Clarifications- Design and Construction of 100 Housing Units at Lh. Naifaru

PROPOSED SITE

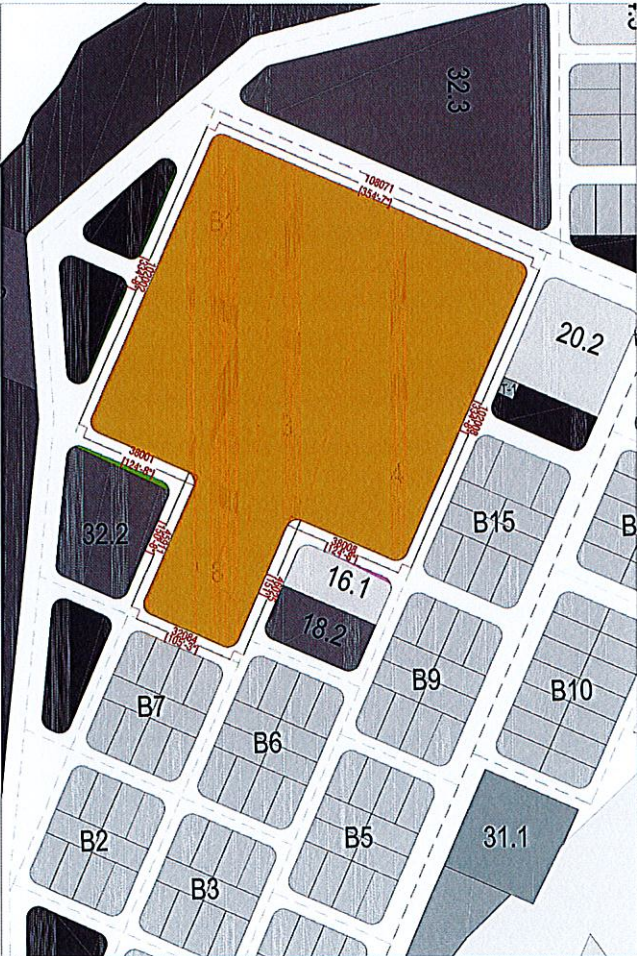
16. Kindly provide the plot location & details

A site location plan is attached with this document.
